TUNITAS CREEK BEACH IMPROVEMENTS PROJECT

**COUNTY PROJECT NO. P30T1
PROJECT FILE NO. E4995**

ADDENDUM NO. 1

The following **Addendum No. 1** to the above referenced project, dated April 21, 2023, shall be included in the project specifications and plans.

1 PARTIAL SITE PLAN
 SCALE: 1"=40'-0"
 NORTH

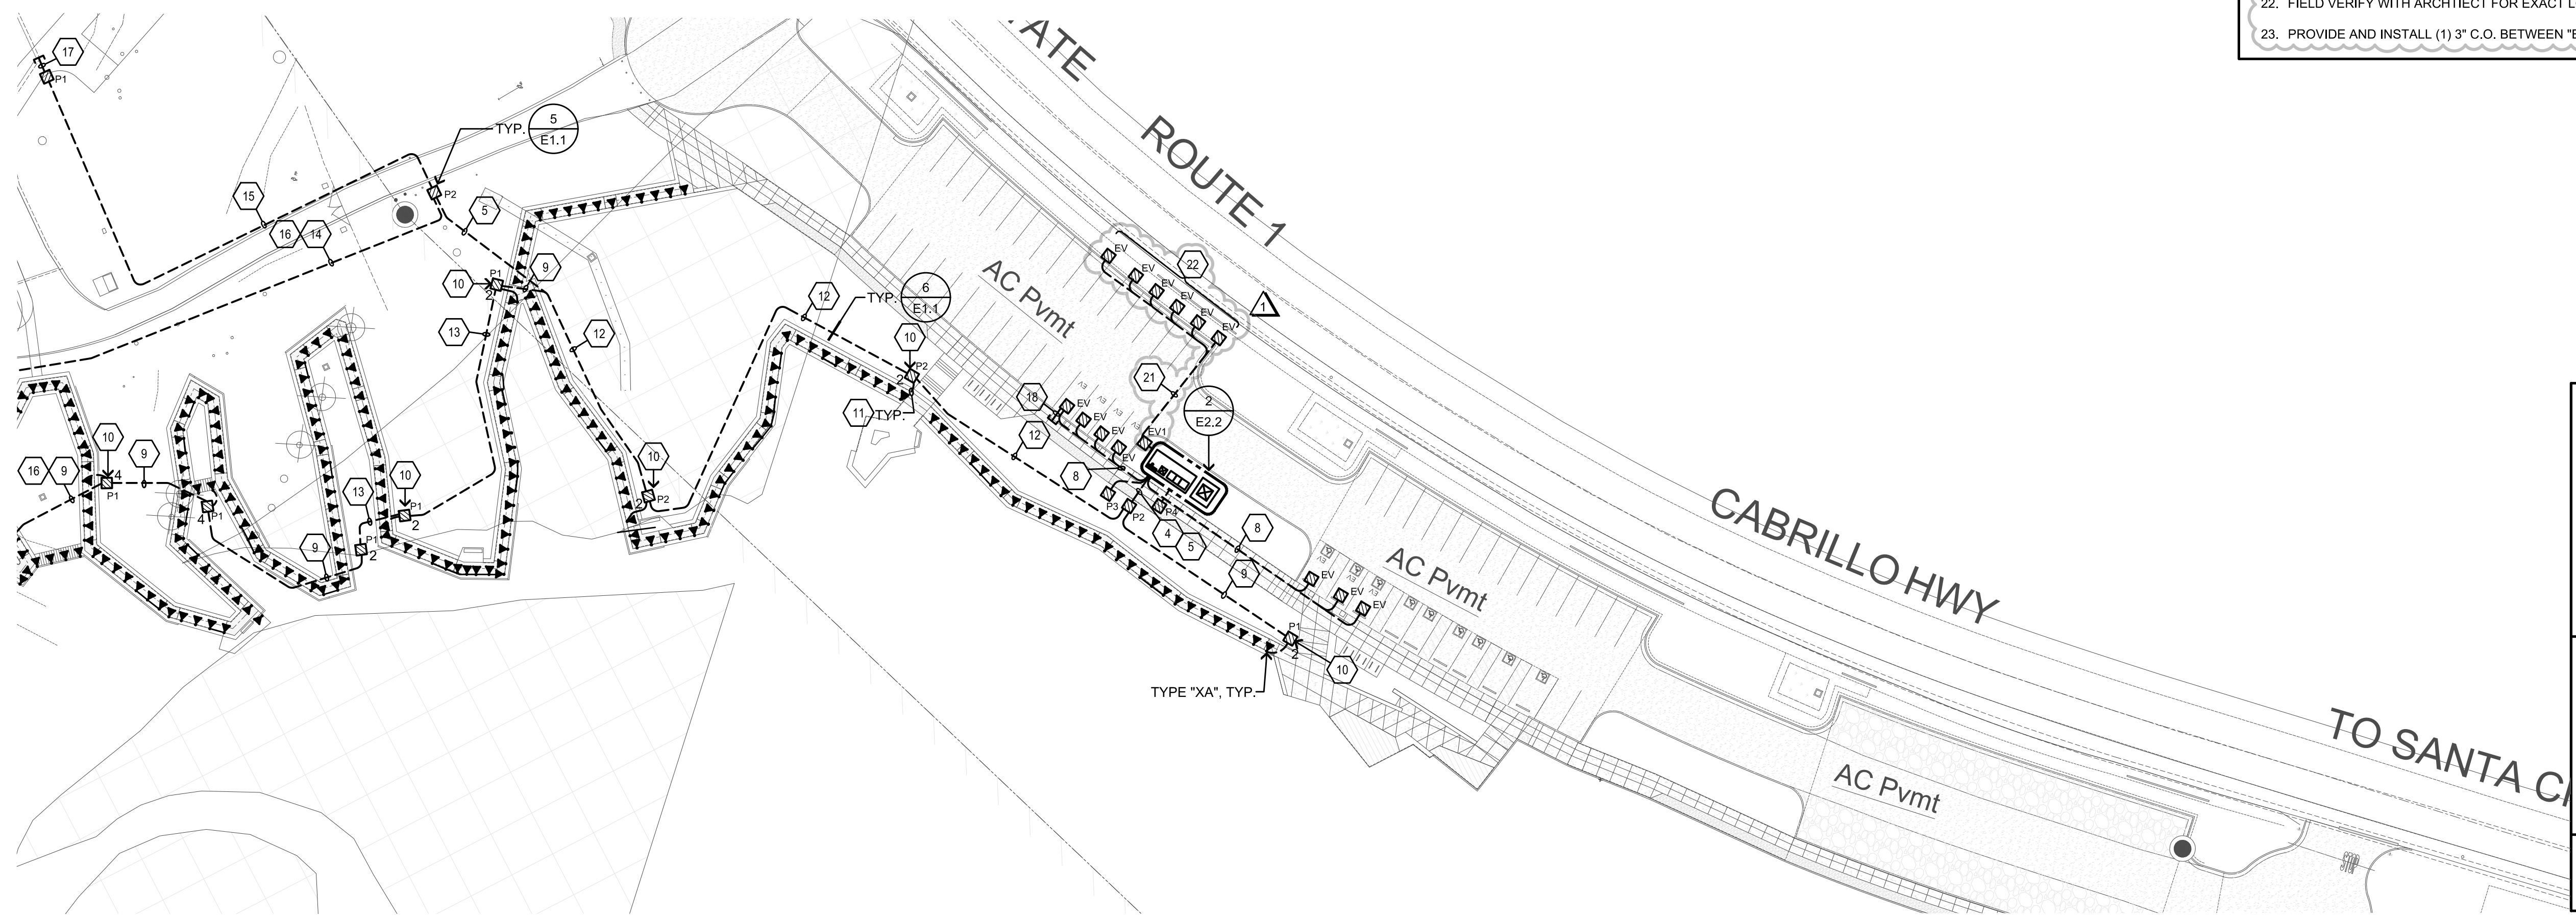
19. The Pullbox Schedule, Sheet Notes 20-23, and Detail 2 of Sheet E2.2 have been updated. Plan Sheet E2.2 shall be replaced in the Project Plans:

Replace Plan Sheet E2.2 (Sheet 106 of 124) with Sheet E2.2 (rev) (Sheet 106 of 124).

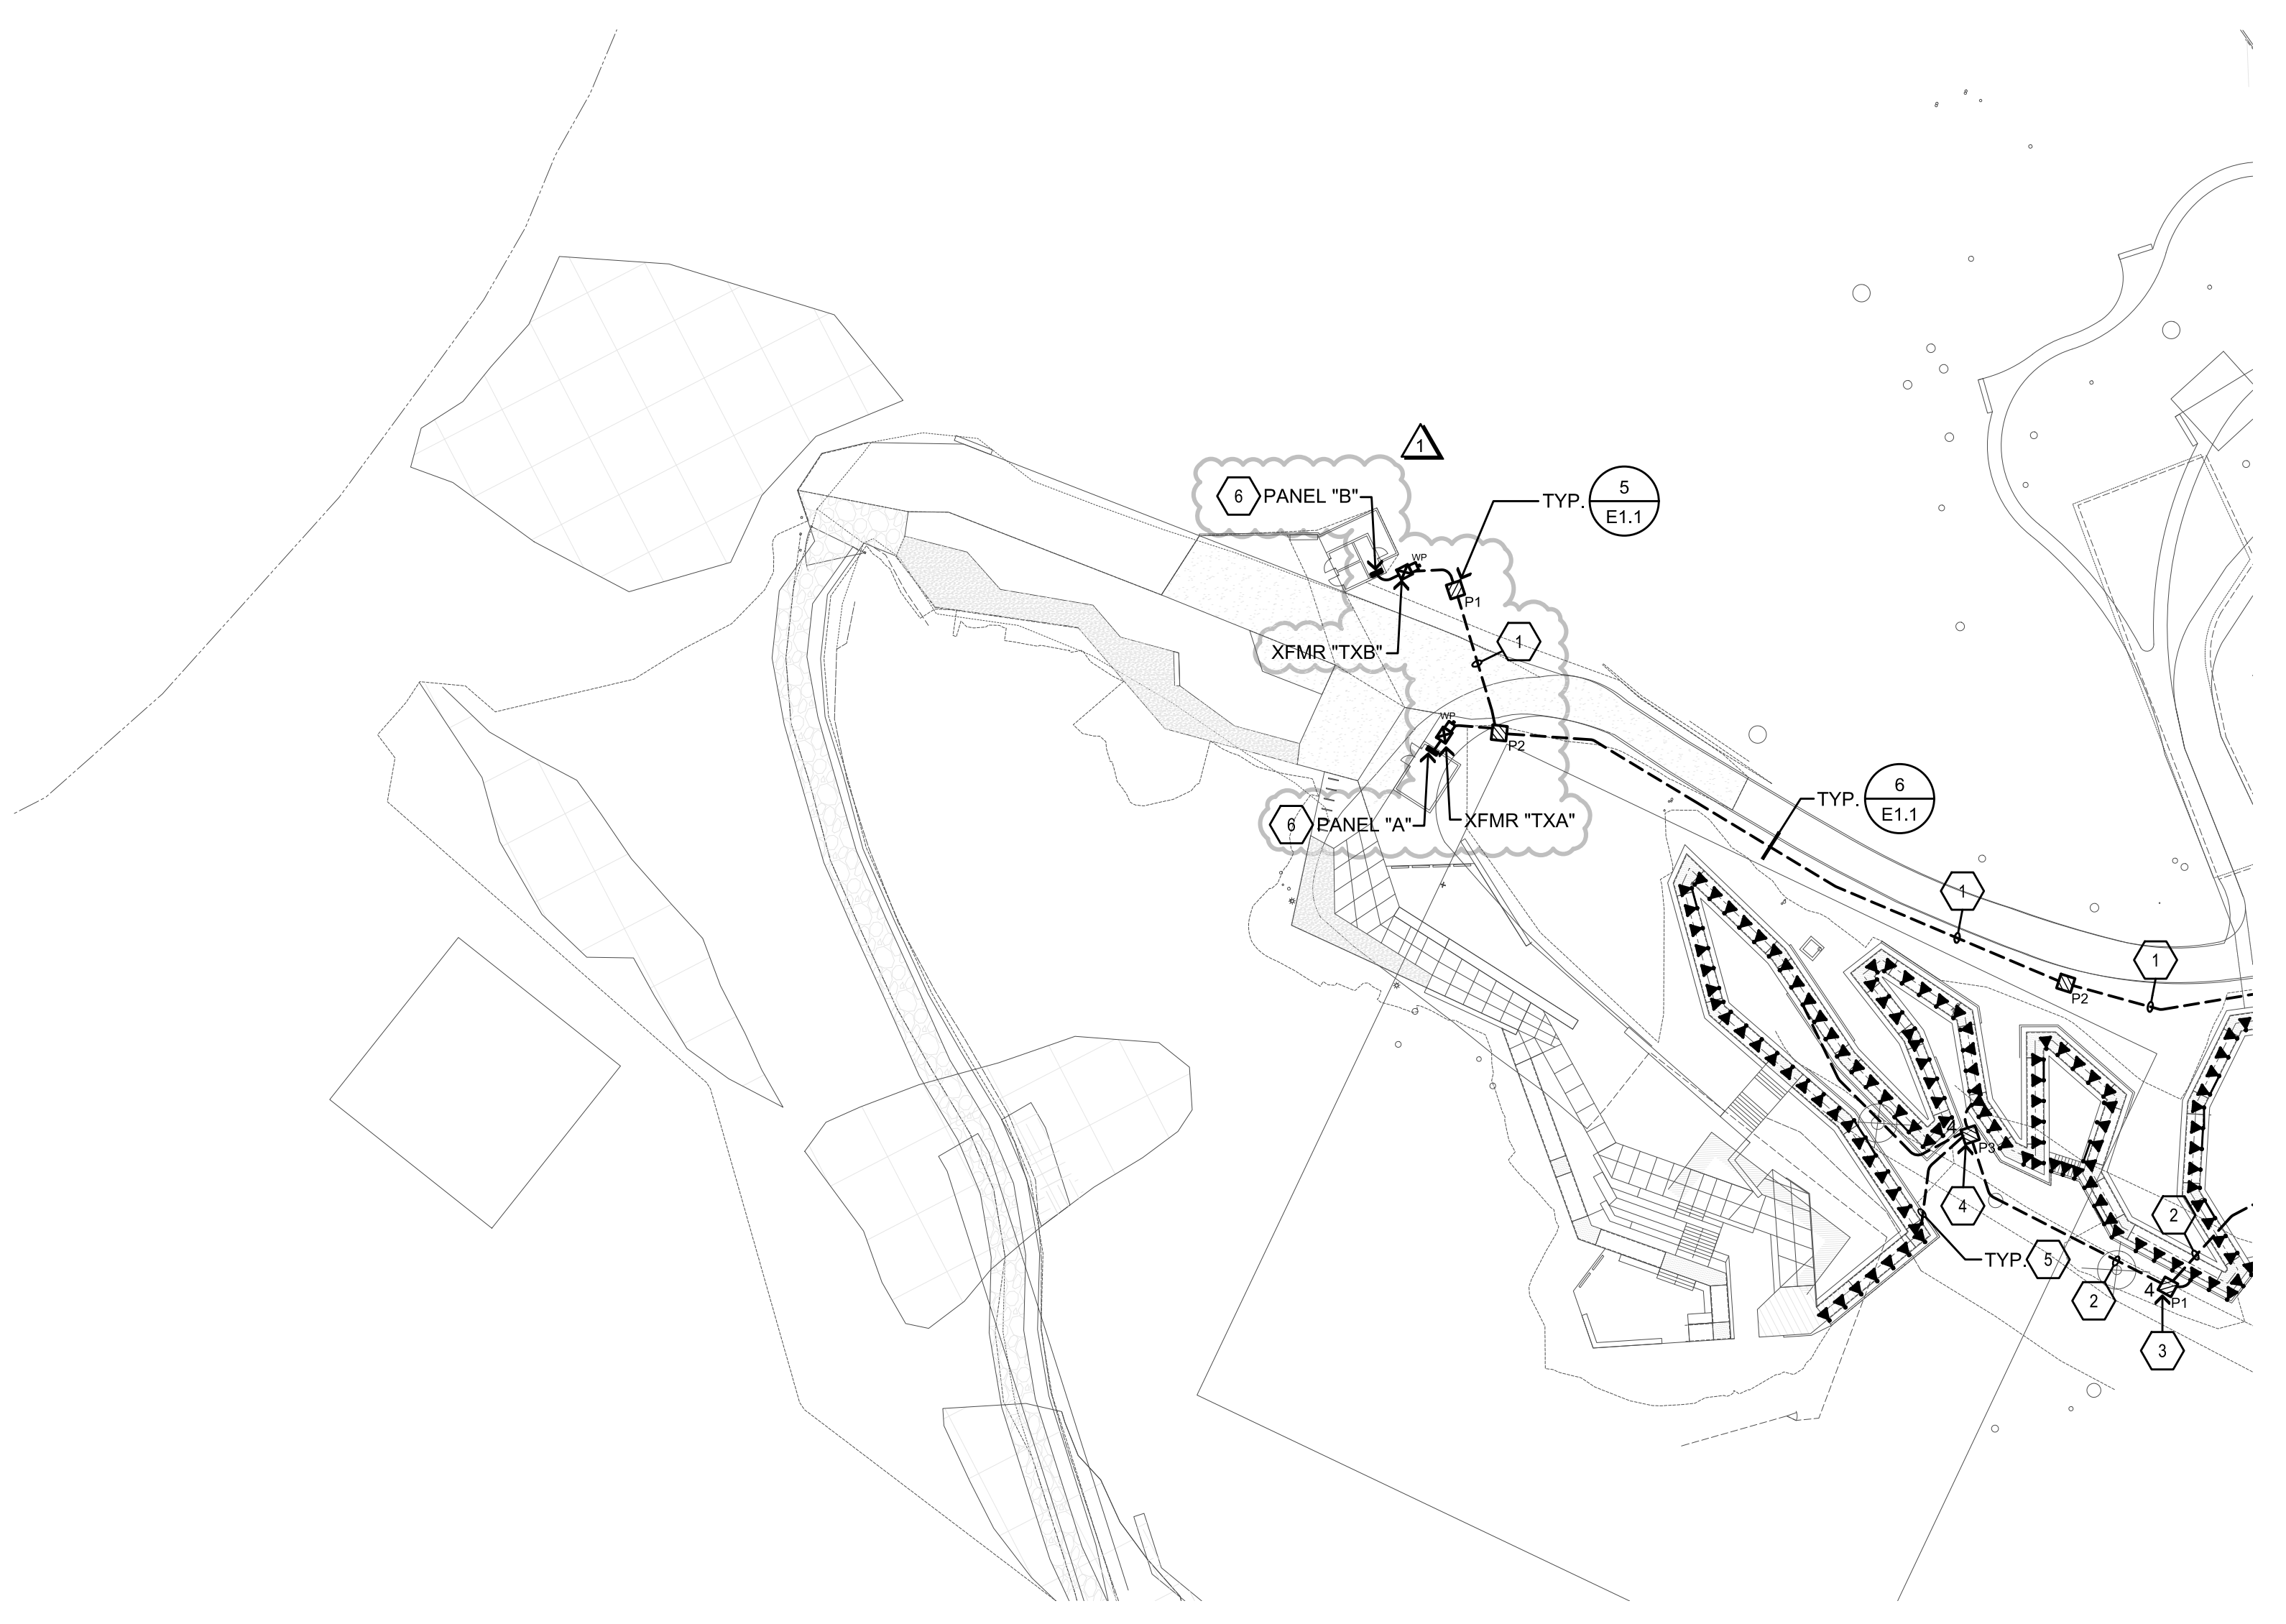
20. The Plan View, and Sheet Notes 1 and 6 have been updated on Sheet E2.3. Plan Sheet E2.3 shall be replaced in the Project Plans:

Replace Plan Sheet E2.3 (Sheet 107 of 124) with Sheet E2.3 (rev) (Sheet 107 of 124).

4 LIGHTING TIME CLOCK
NO SCALE

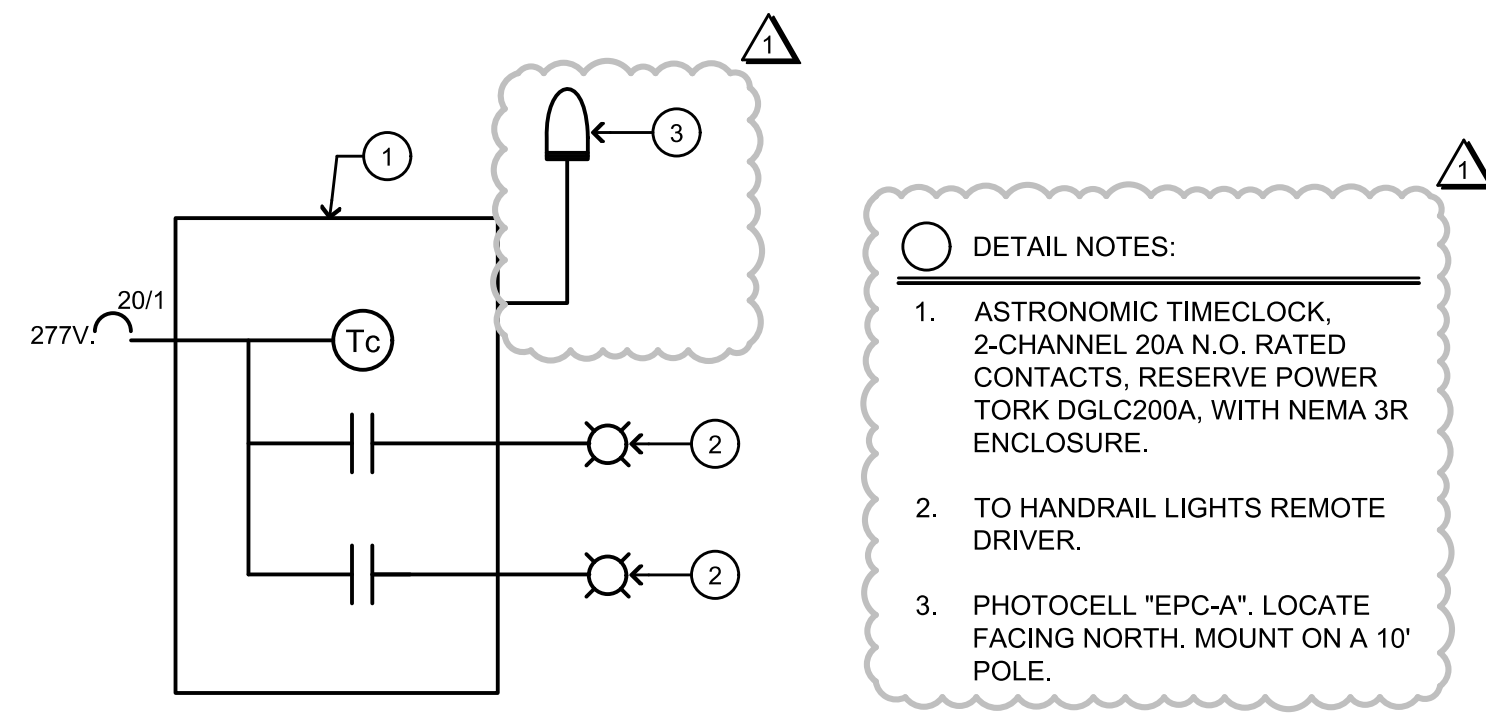
21. Detail 1 and Detail 4 have been updated on Sheet E6.1. Plan Sheet E6.1 shall be replaced in the Project Plans:

Replace Plan Sheet E6.1 (Sheet 108 of 124) with Sheet E6.1 (rev) (Sheet 108 of 124).
